# UNITED STATES PATENT AND TRADEMARK OFFICE

10/576,069

| <b>Office Action Summary</b> | <b>Application No.</b><br>10/576,069 | <b>Applicant(s)</b><br>PODOLEANU, ADRIAN |  |

## **Detailed Action**

(modified figure 3)

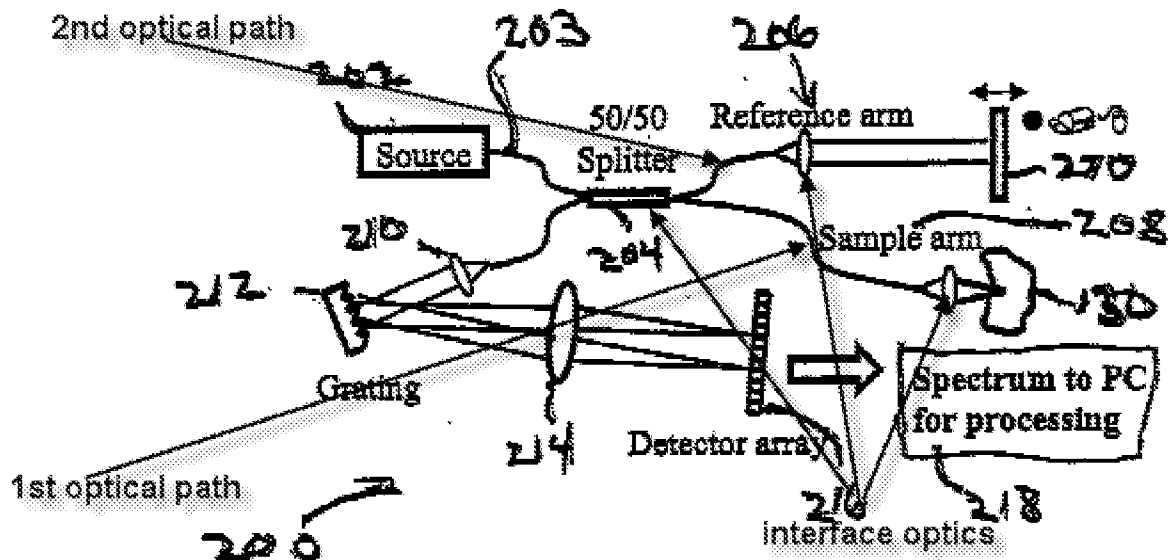
Regarding **Claims 11, 33, & 93**, de Boer discloses the aforementioned. Further, a first optical path and second optical path and interface optics are shown (see modified figure 3);

de Boer fails to show a third optical path where the optical output beam from the object are transferred to the displacing means and a processing means to control the optical path difference ;

However, de Boers does disclose optionally using phase modulators such as acousto-optic, electro-optic, or the like. These would lend themselves to having both the

reference and object beam displaced which is an obvious modification that the examiner takes official notice is well known to one of ordinary skill in the art.

Therefore, it would have been obvious to one of ordinary skill in the art at the time of invention to have a third optical path where the optical output beam from the object is transferred to the displacing means because displacing both the reference and object beam allow for faster stepping of the phase shift between the two and allow for more depth in scanning in an OCT apparatus.

de Boer still fails to show a processing means to control the optical path difference;

However, the examiner takes official notice that this is well known and obvious to one of ordinary skill in the art;

Therefore, it would have been obvious to one of ordinary skill in the art at the time of invention to have a processing means to control the optical path difference because in order for interference to occur the optical path difference must lie within the coherence length of the light thus a processor would allow for fine tuning of that difference and lead to faster scanning and better image quality.
